Item Name: Crosstube Turning Detail

DART AEROSPACE LTD		Work Order:	112951
Description: Crosstube Assembly (206B High Fwd)		Part Number:	D206-667-141
Inspection Dwg: D206-667-141 Rev: C		Page 1 of 2

DRAWING NO. D206-667-141	TITLE CROSSTUBE ASS'Y (206B HIGH FWD)	REV. C	DART AEROSPACE LTD ENGINEERING ORDER		D.E.O. NO. D206-667-141-C-1	SHEET NO. SHEET 1 OF 1	SCALE NTS
DRAWN <i>Q</i>	CHECKED <i>ASS</i>	MFG. APPR. <i>MD</i>	APPROVED <i>MD</i>		DE APPR. <i>MD</i>		
DATE 11.07.15	DATE 11.07.20	DATE 11.07.21	DATE 11/07/21		DATE 11.07.21

DRAWING NO. D206-667-141	TITLE CROSSTUBE ASS'Y (206B HIGH FWD)	REV. C	DART AEROSPACE LTD ENGINEERING ORDER		D.E.O. NO. D206-667-141-C-2	SHEET NO. SHEET 1 OF 1	SCALE NTS
DRAWN AJS	CHECKED	MFG. APPR. <i>E</i>	APPROVED <i>AP</i>		DE APPR. <i>H</i>		
DATE 12.08.02	DATE 12.08.02	DATE 12.08.02	DATE 12.08.02		DATE 12.08.02

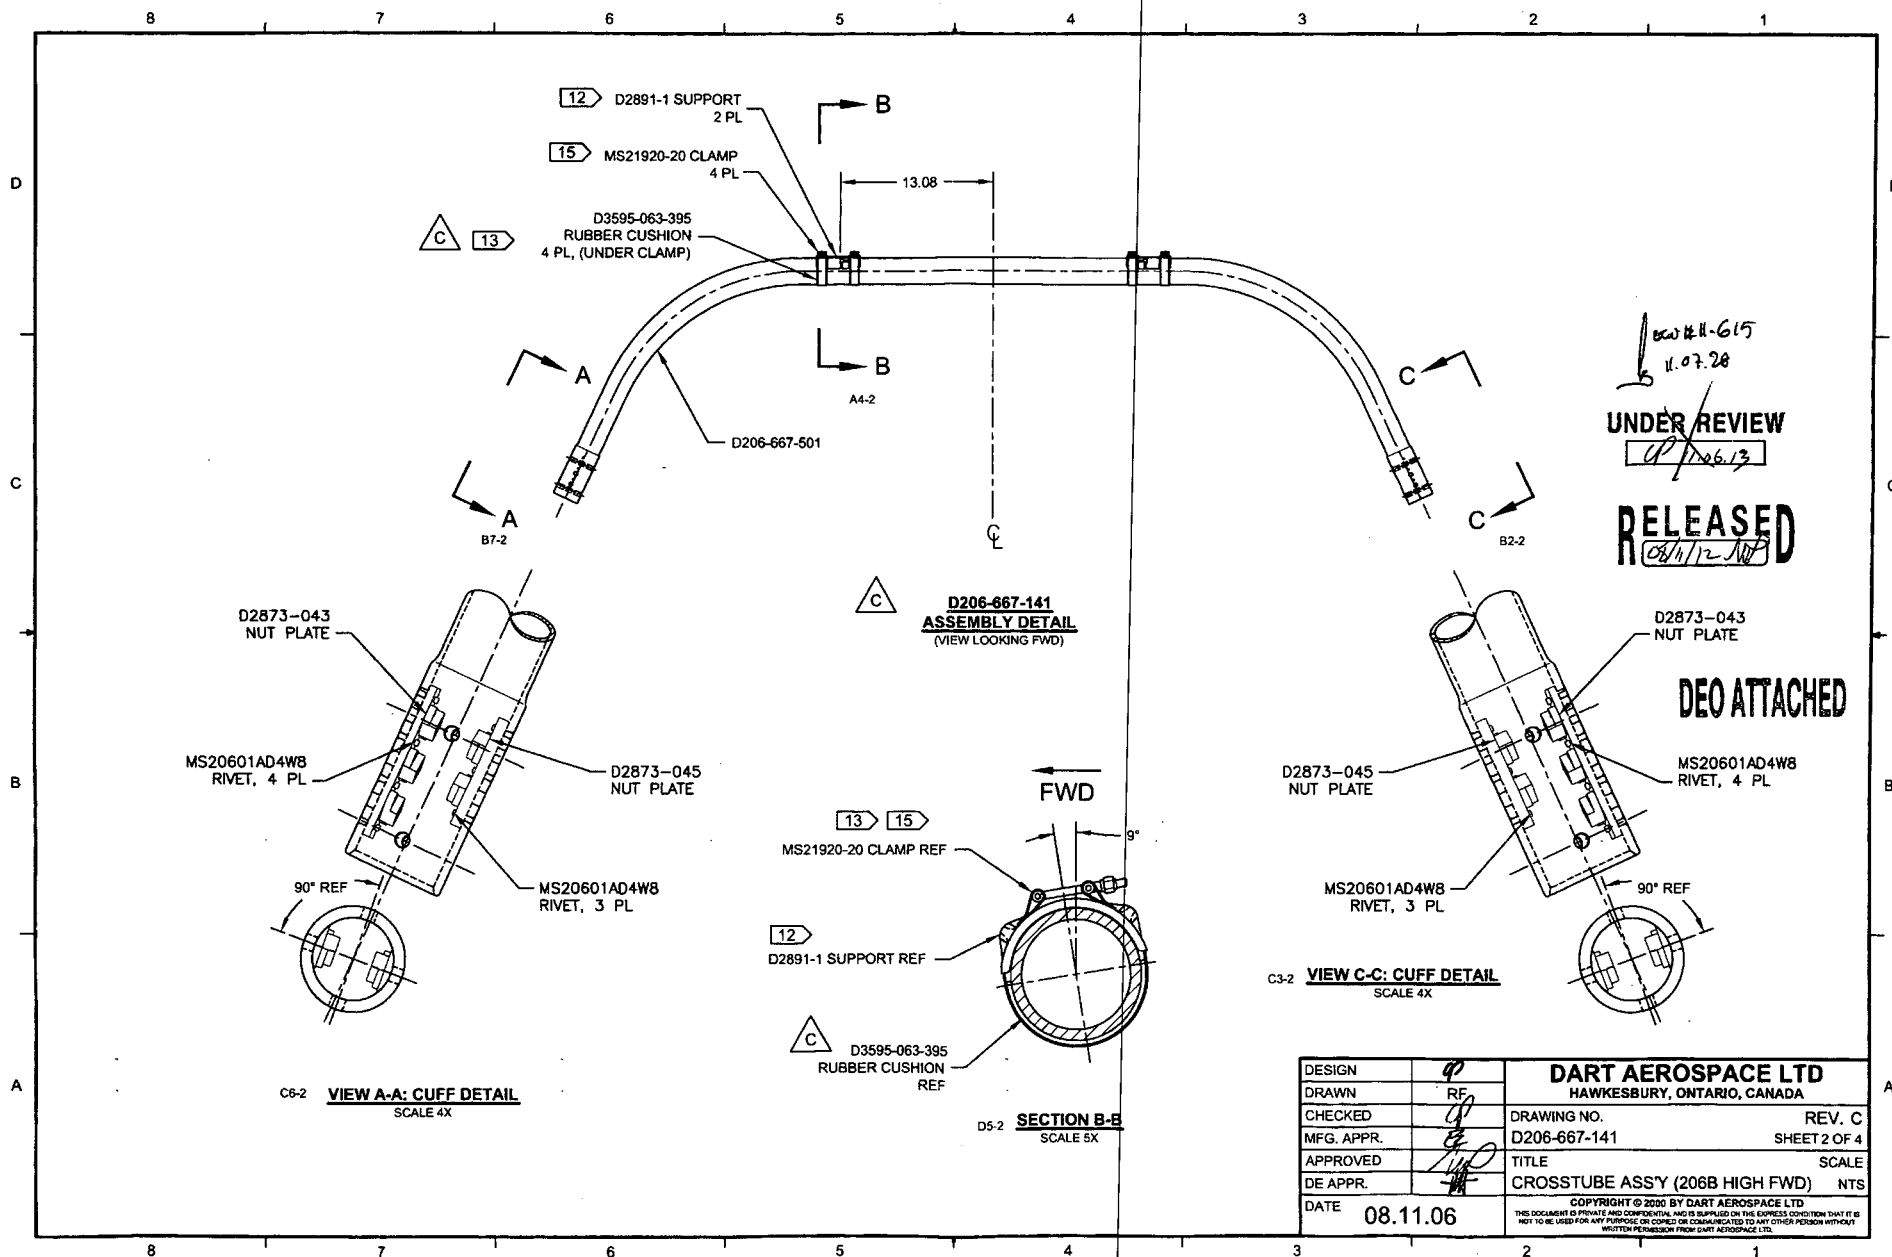
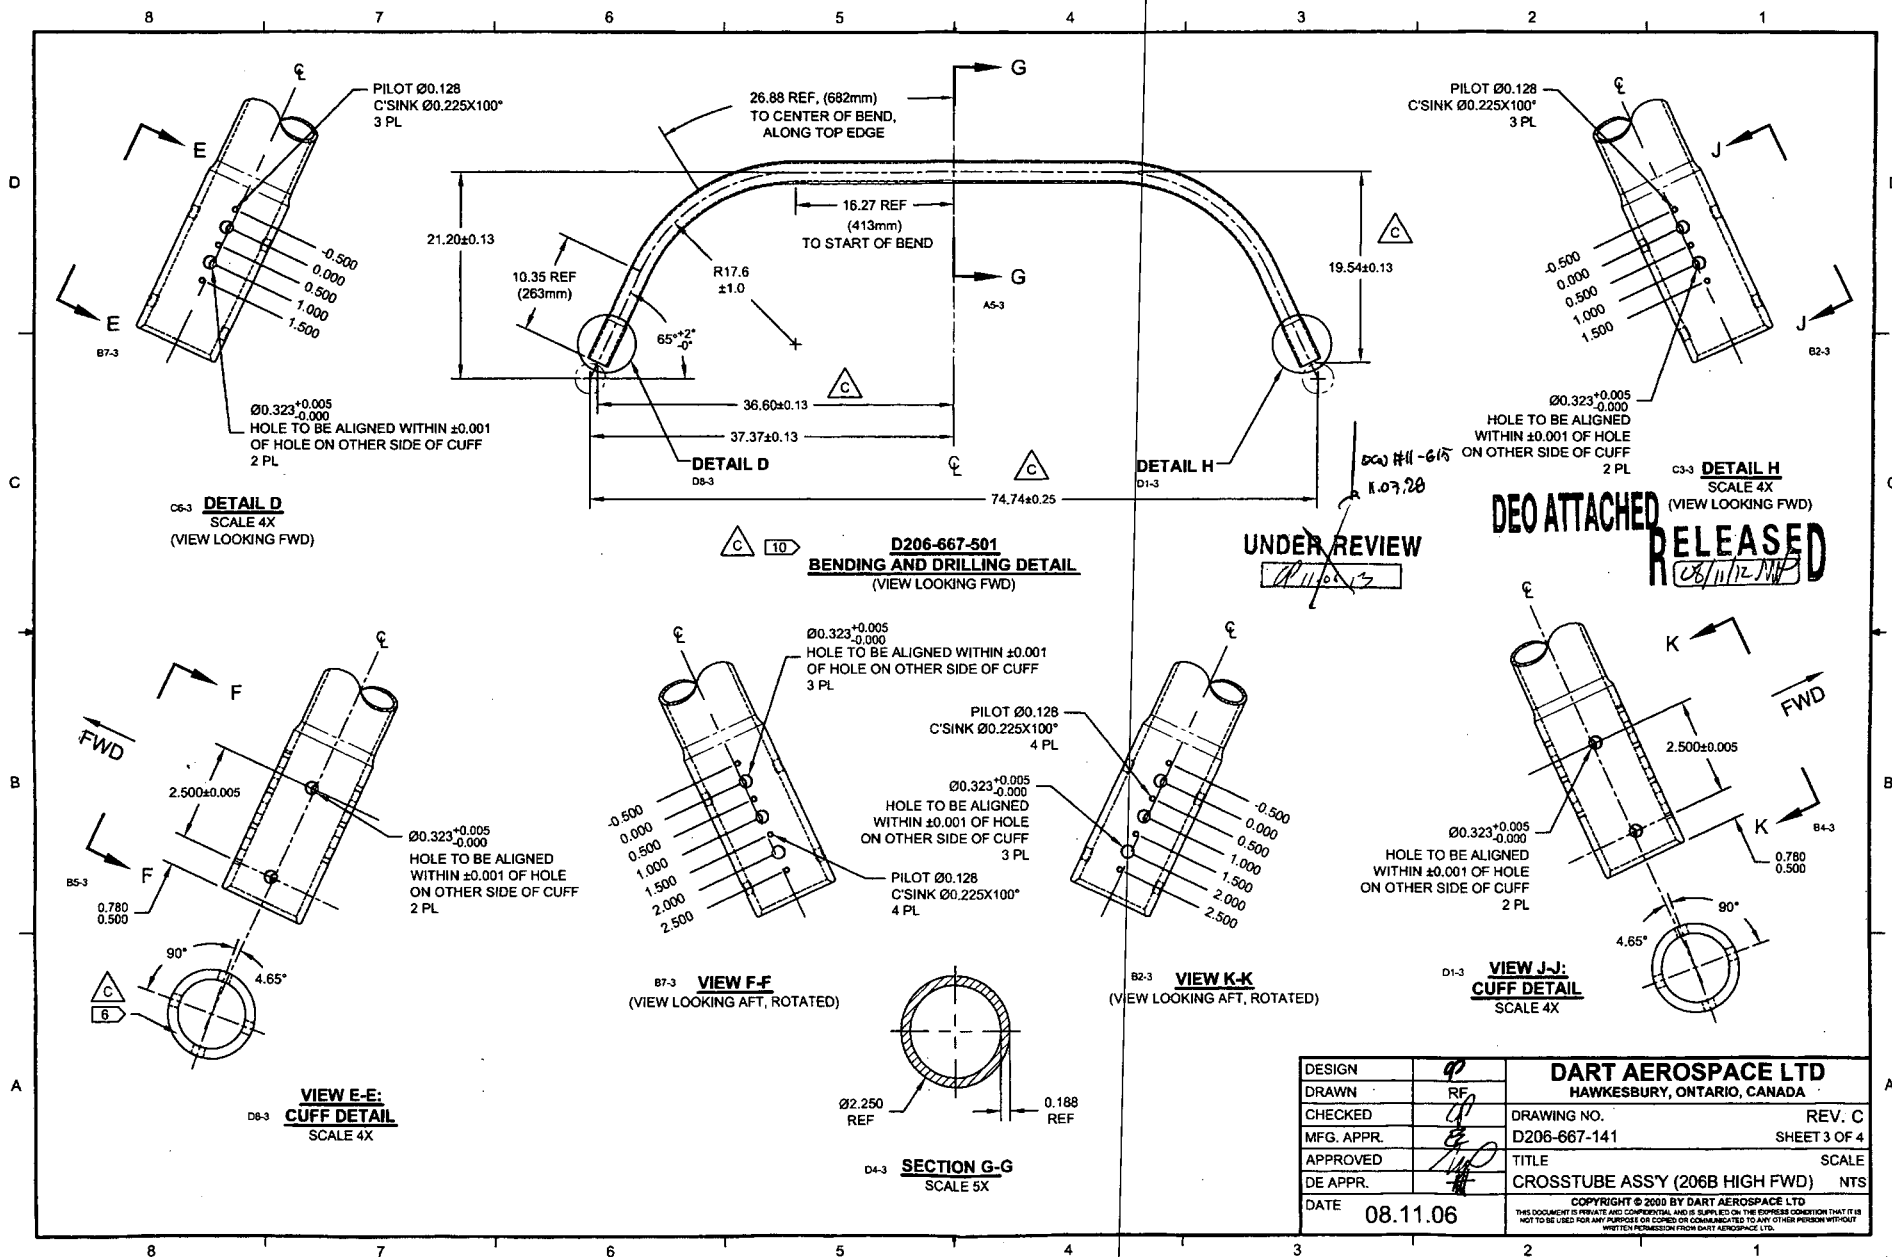
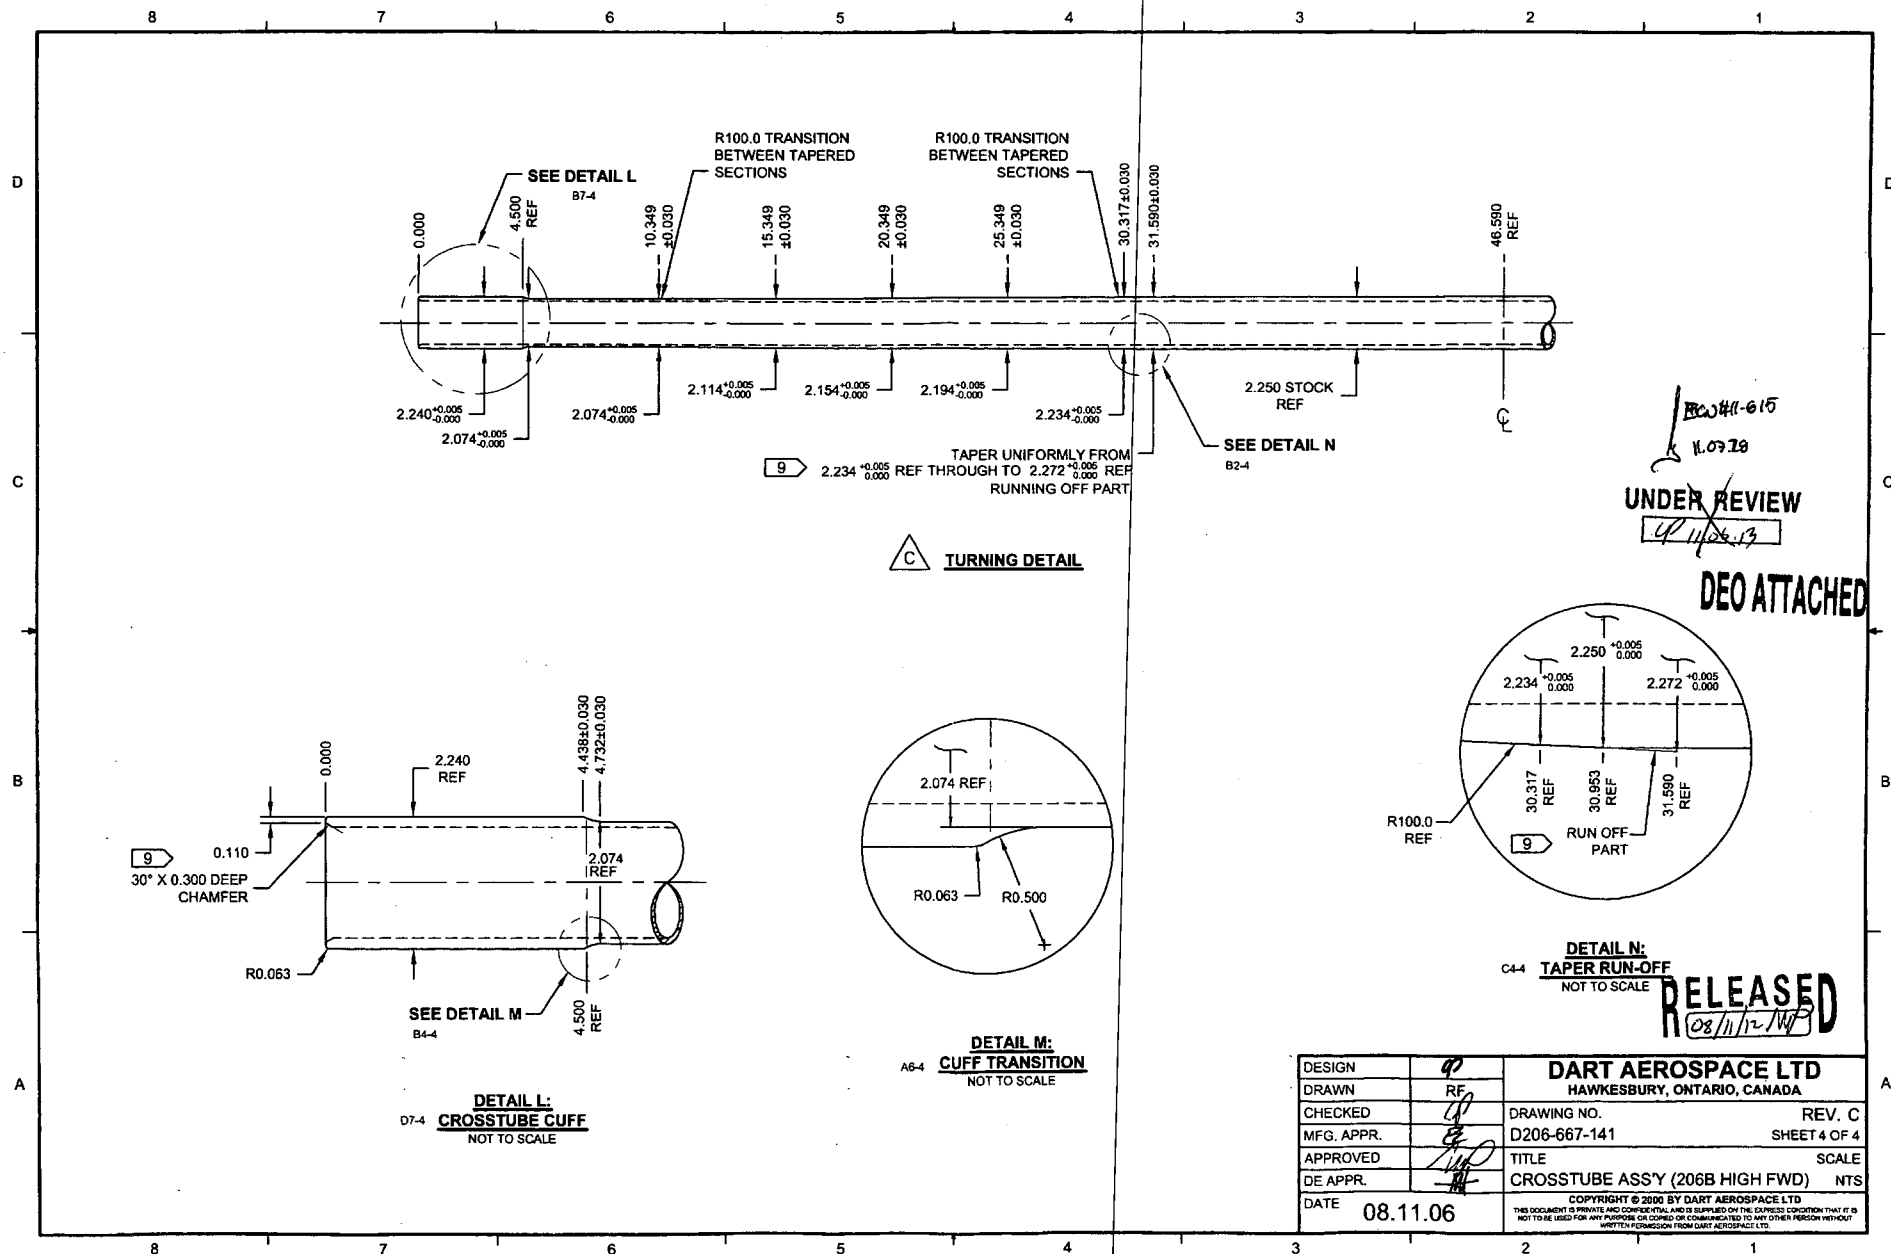
C	REVISE GENERAL NOTES/PART LIST (ZN D7-1); REORGANIZED VIEWS AND REFORMATTED DRAWING TO CURRENT STANDARDS. D3595-063-395 WAS D2856-400-694 (ZN D6-2 & A5-2); REMOVED REF. & ADD TOLERANCES (ZN C4-3, C5-3 & D3-3); RELOCATED FLAG #6 (ZN A8-3) PER NCR 210; MOVED TURNING DETAIL & UPDATED TOLERANCE TO SHEET 4.	RF	08.11.06
B	ADD HOLES AND NUT PLATES FOR COMPATABILITY WITH BHT/AA SKUDTUBES	PH	05.07.26
A	NEW ISSUE	CP	00.11.17
REV.	DESCRIPTION	BY	DATE
DESIGN	<u>RF</u>	DART AEROSPACE LTD HAWKESBURY, ONTARIO, CANADA	
DRAWN	<u>RF</u>	DRAWING NO.	REV. C
CHECKED	<u>RF</u>	D206-667-141	SHEET 1 OF 4
MFG. APPR.	<u>RF</u>	TITLE	SCALE
APPROVED	<u>RF</u>	CROSSTUBE ASSY (206B HIGH FWD)	NTS
DE APPR.	<u>RF</u>	COPYRIGHT © 2009 BY DART AEROSPACE LTD THIS DOCUMENT IS PRIVATE AND CONFIDENTIAL AND IS SUPPLIED ON THE EXPRESS CONDITION THAT IT IS NOT TO BE USED FOR ANY PURPOSE OR REPRODUCED OR COMMUNICATED TO ANY OTHER PERSON WITHOUT WRITTEN PERMISSION FROM DART AEROSPACE LTD.

DETAIL P
BONDING STRAP INSTALLATION 2 PL

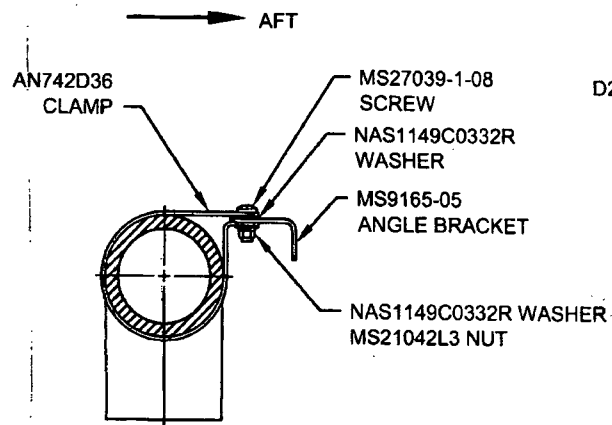
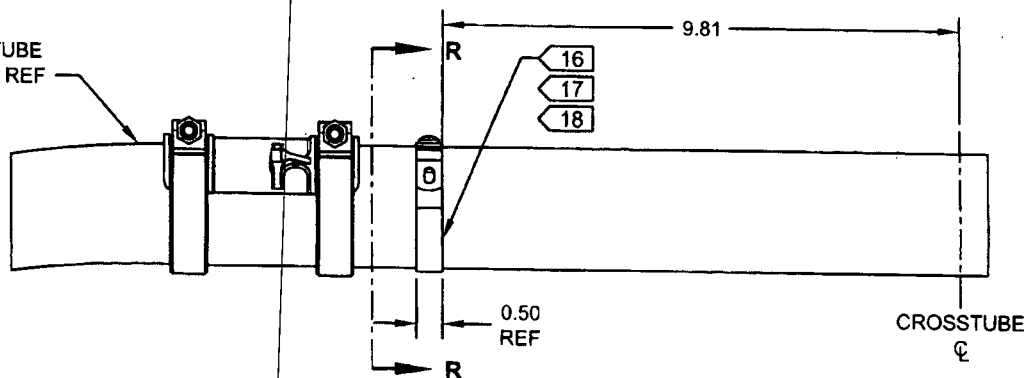
ADD ELECTRICAL GROUNDING STRAP

- 16) MASK AREA UNDER CLAMP PRIOR TO PAINTING
- 17) SEAL EDGES WHERE AN742D36 CLAMP MEETS WITH THE CROSSTUBE USING SIKAFLEX-241/-291 OR MIL-S-8802 CLASS B2 OR PROSEAL 890 SEALANT
- 18) PERFORM RESISTANCE CHECK TO ENSURE MAX RESISTANCE IS 10 MILLIOHMS
